ADDENDUM NUMBER THREE

DARLA MOORE SCHOOL OF BUSINESS CONSTRUCTION – BP-3
ENCLOSURE/SITE/MEFP/INTERIOR
UNIVERSITY OF SOUTH CAROLINA
STATE PROJECT NUMBER H27-6069-AC-3

DATE OF ISSUE: June 22, 2012

**ENLARGED FLOOR PLAN
LEVEL 2
ZONE A**

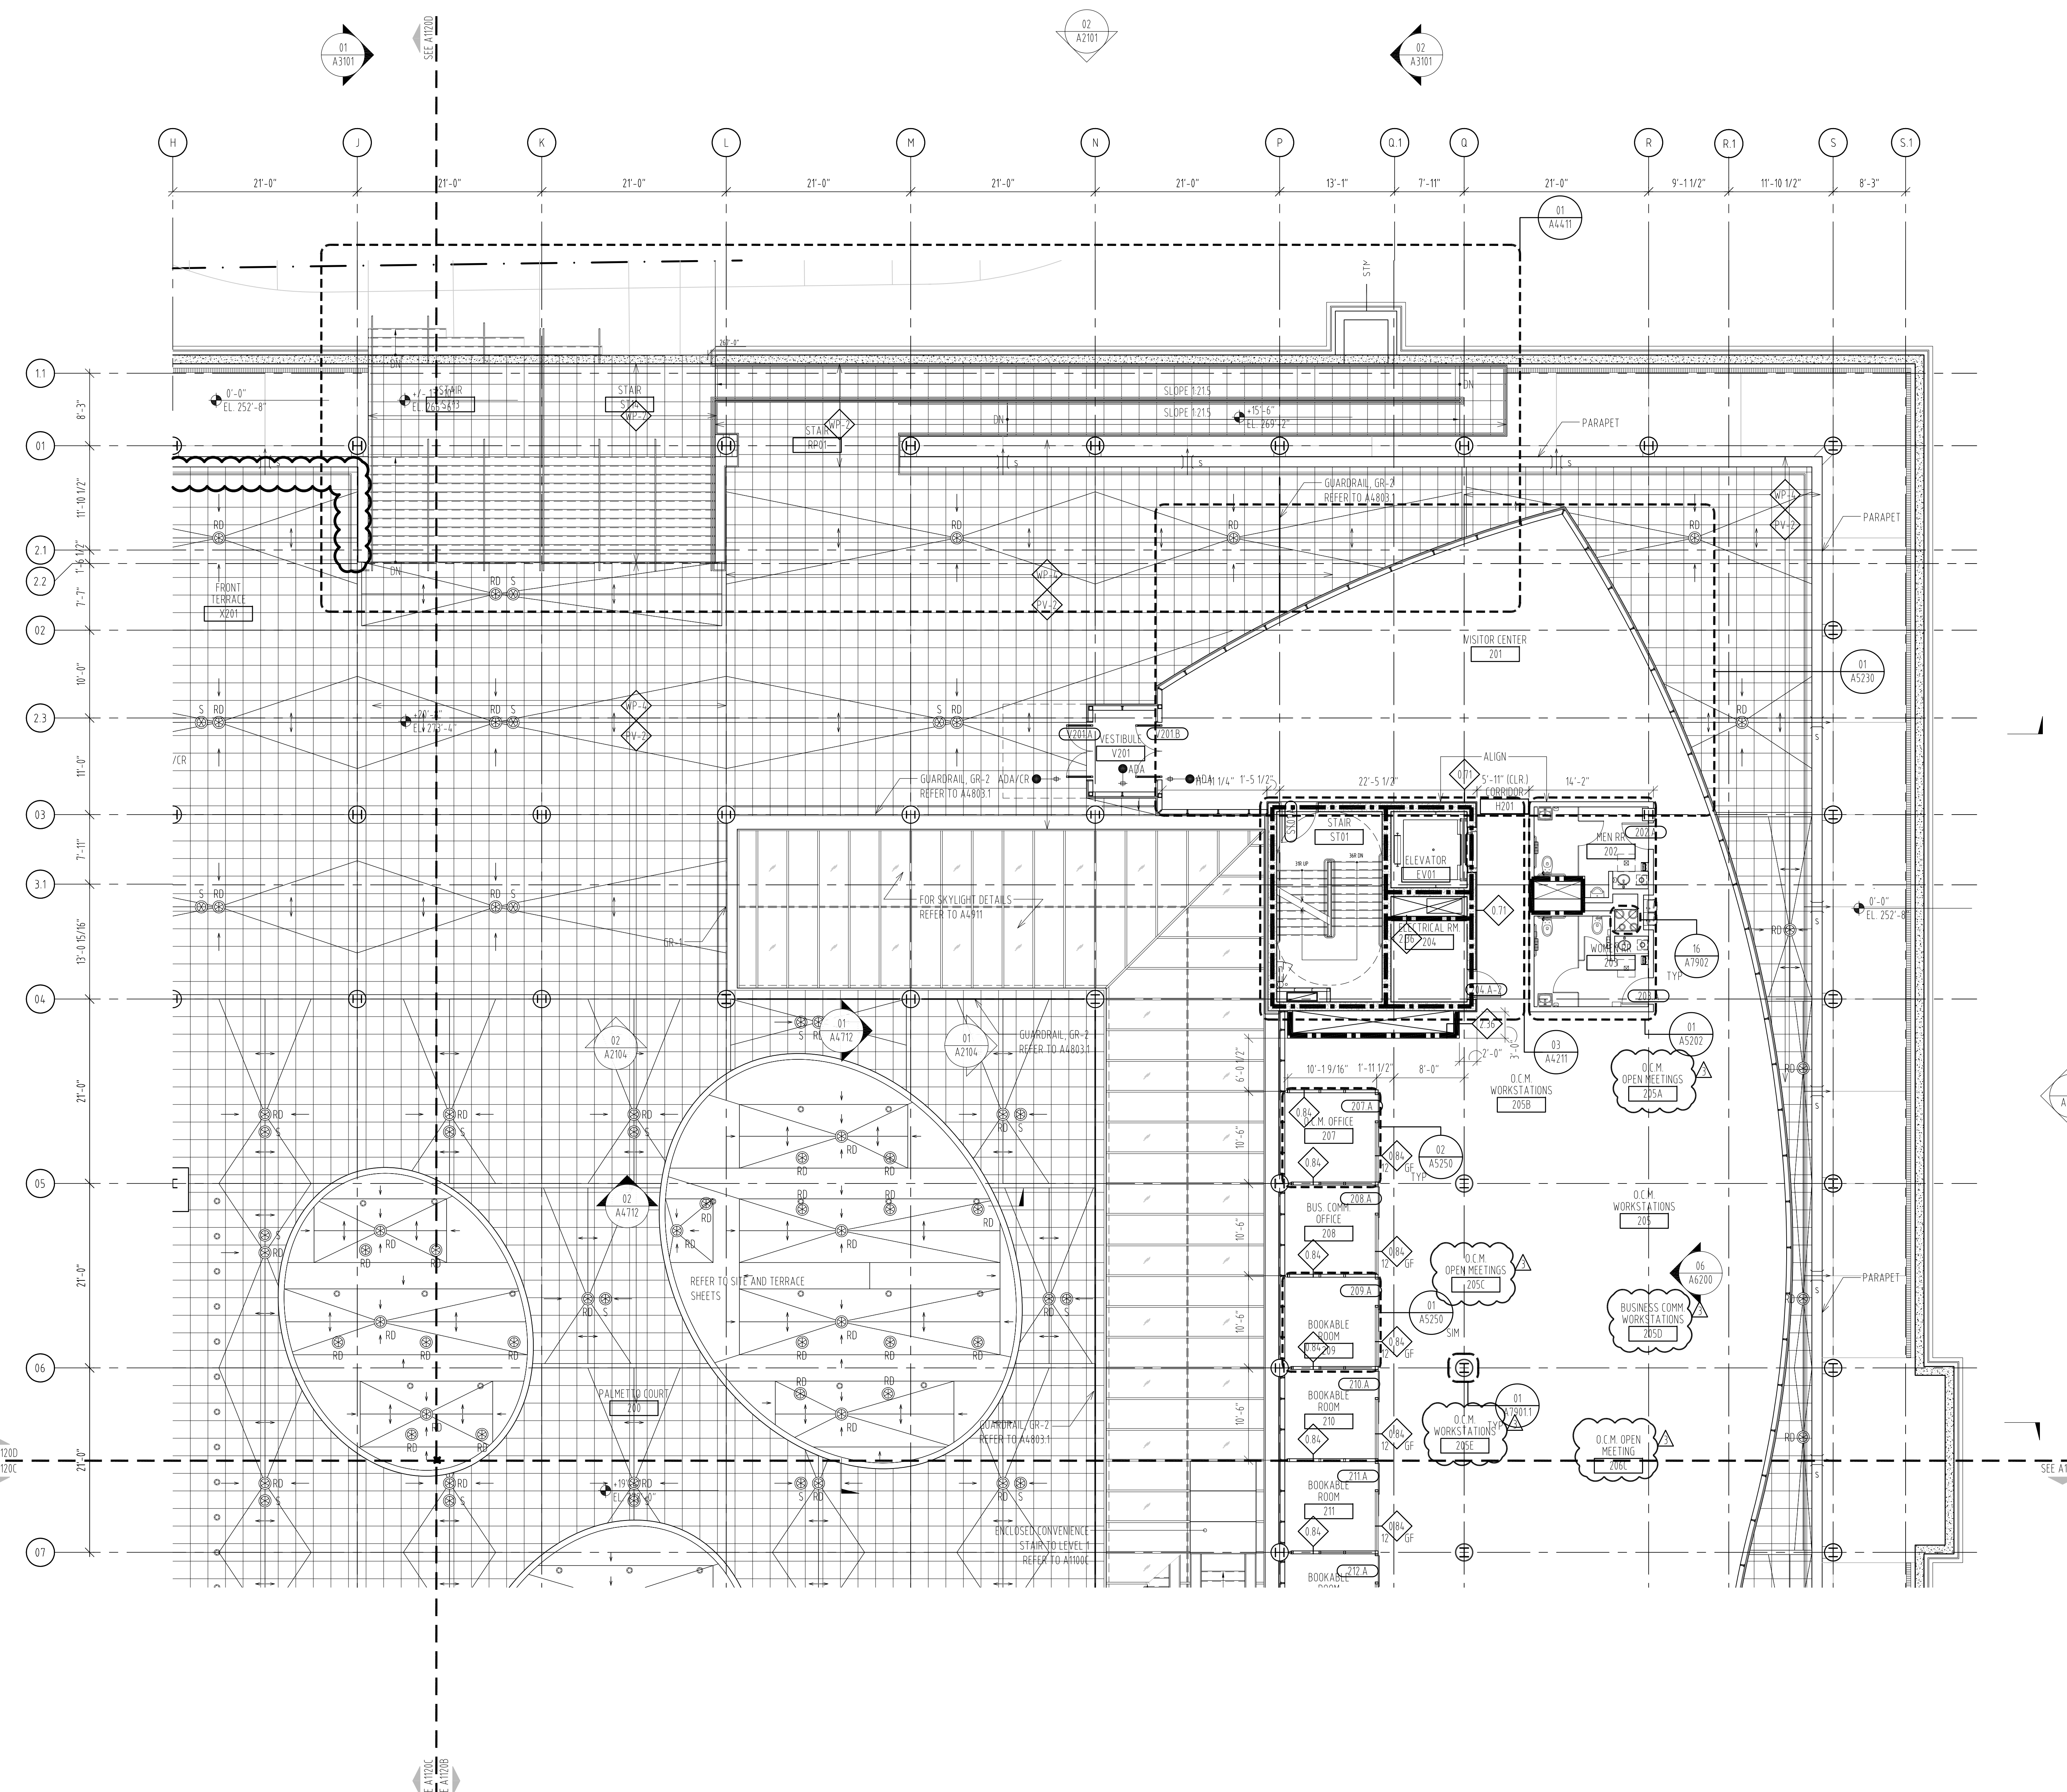
| 3. | Sheet A1120A, A1120B, A1120C, A1120D Enlarged Floor Plan – level 2. Refer to A-SK-050, A-SK-051, A-SK-052, A-SK-053 - Door and room tag revision. |

SCALE :
3/32" = 1'-0"
SHEET NUMBER :
A-SK-056

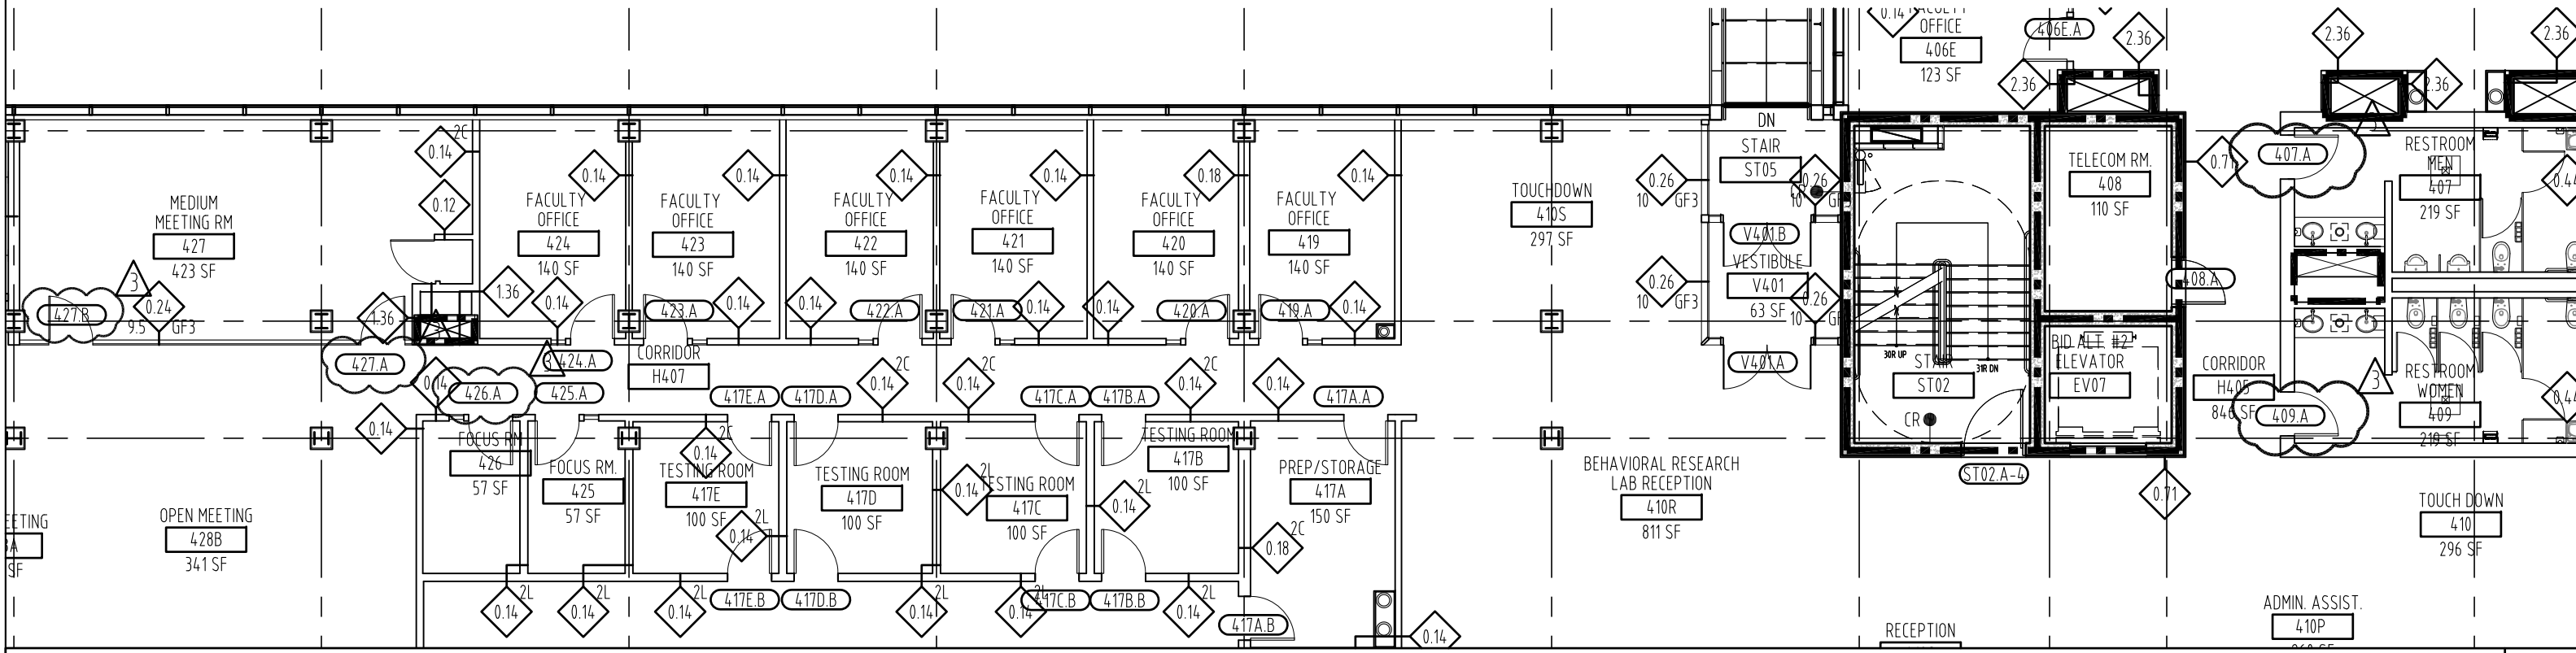
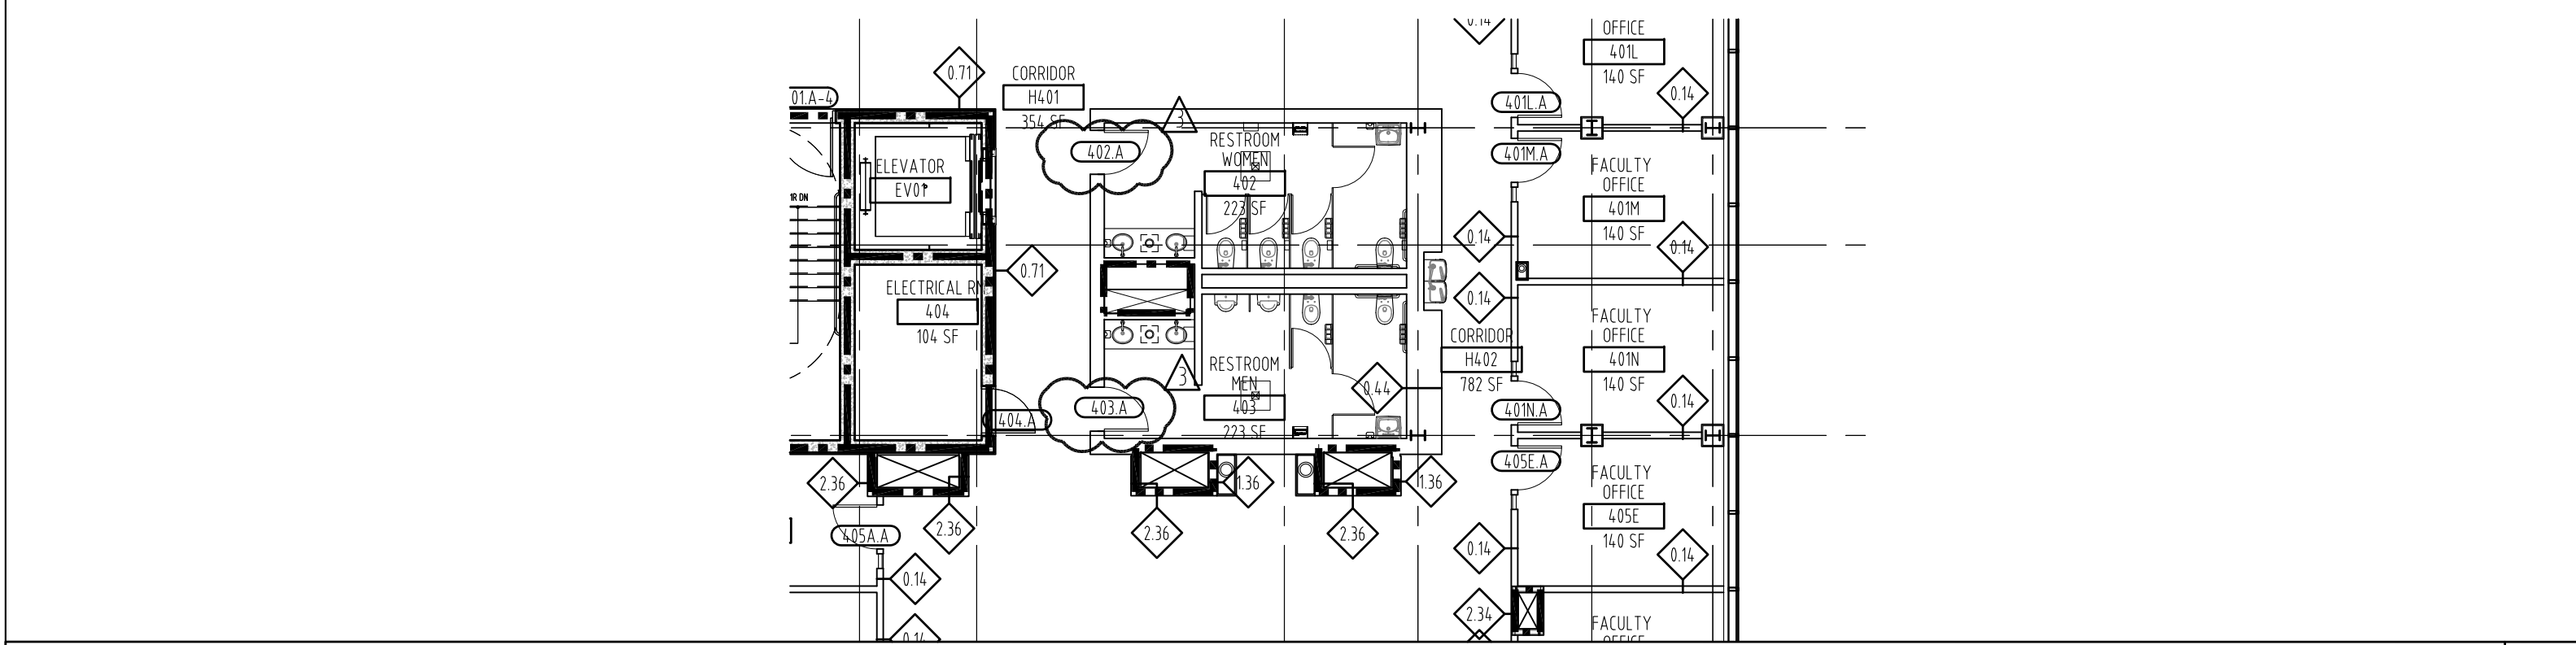
4. Sheet A 1130, A 1130A, A 1130C: Floor plan – Level 3. Refer to A-SK-054 & A-SK-055 - Door and room tag revision.
5. Sheet A1140A, A1140B, A1140C, A1140D: Floor Plan – Level 4. Refer to A-SK-056 & A-SK-057 - Door and room tag revision.
